SERVICE BULLETIN

No. 527

Piper Aircraft Corporation

Electric Trim Switch Modification

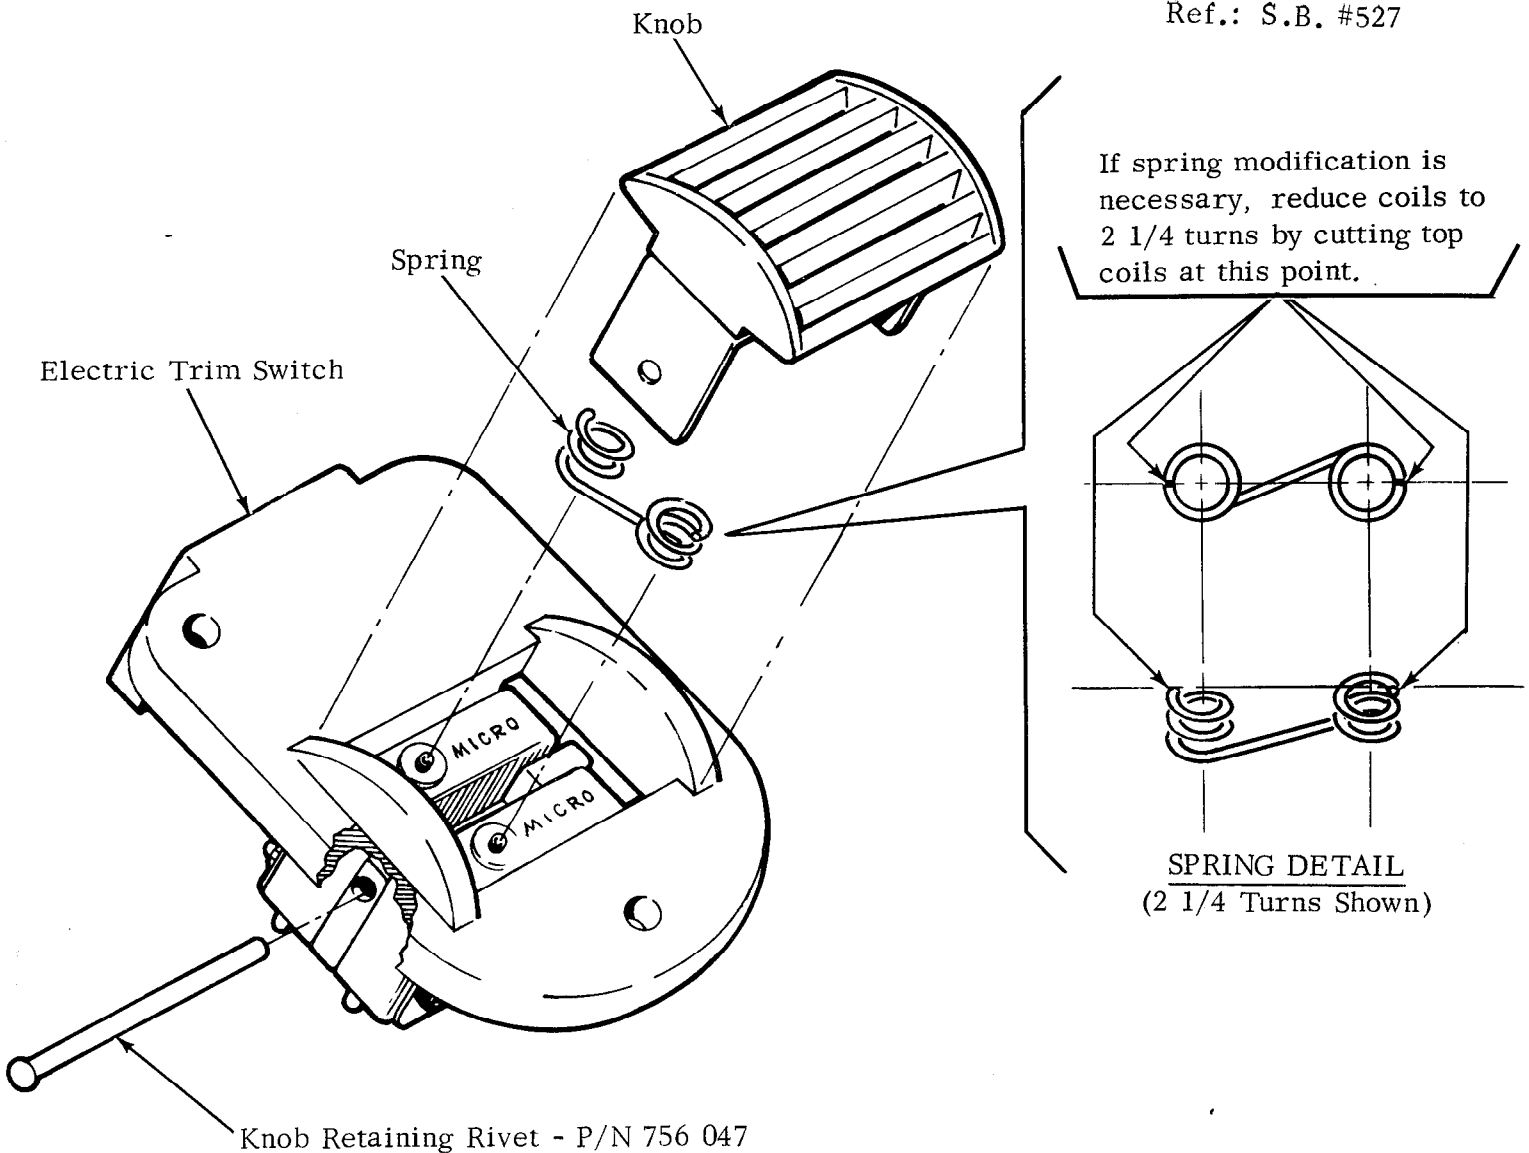
Purpose: Field reports describe a condition wherein the pilot's control wheel mounted "rocker" type electric trim switch tends to "hang up" in the "FWD"/"NOSE UP" or "AFT"/"NOSE DOWN" mode; i.e., fails to return to the "neutral" position following removal of thumb pressure. This condition occurred on some aircraft modified in accordance with Service Bulletin No. 331. Subsequent investigation revealed that the switch return coil springs supplied with Piper Kit No. 760 505 (Electric Trim Switch Modification), per Service Bulletin No. 331 and subsequent production modified models--for a period of time--had an excessive number of coils, which may cause the end of the coil spring to become caught between the switch "rocker" actuator and the micro switch body, thus preventing spring assisted return of the switch to "neutral".

To remedy--and prevent--this condition, this service release provides instructions to modify the electric trim switch return spring by reducing the number of coils (from 2 1/2 turns to 2 1/4 turns--reference attached sketch/instruction sheet for an illustrated view of this condition).

4. Remove knob and spring from switch.
5. Inspect spring to determine if coils consist of 2 1/4 turns as shown in above detail or 2 1/2 turns.
 - a. If coils consist of 2 1/4 turns, proceed to Step 6.

- b. If coils consist of 2 1/2 turns, modify spring by cutting 1/4 turn from top of coils before proceeding to Step 6. Refer to spring detail above.
6. Place spring (P/N 757 685 - Scott #10004324) over micro-switch buttons with open ends of spring facing up. Spring coils must be concentric with micro-switch buttons and shoulders, and must not rest upon them.

7. Place knob in position and depress slightly so that the new retaining rivet (P/N 756 047 - Scott # 36270) can be installed. Take care not to dislodge spring from position.
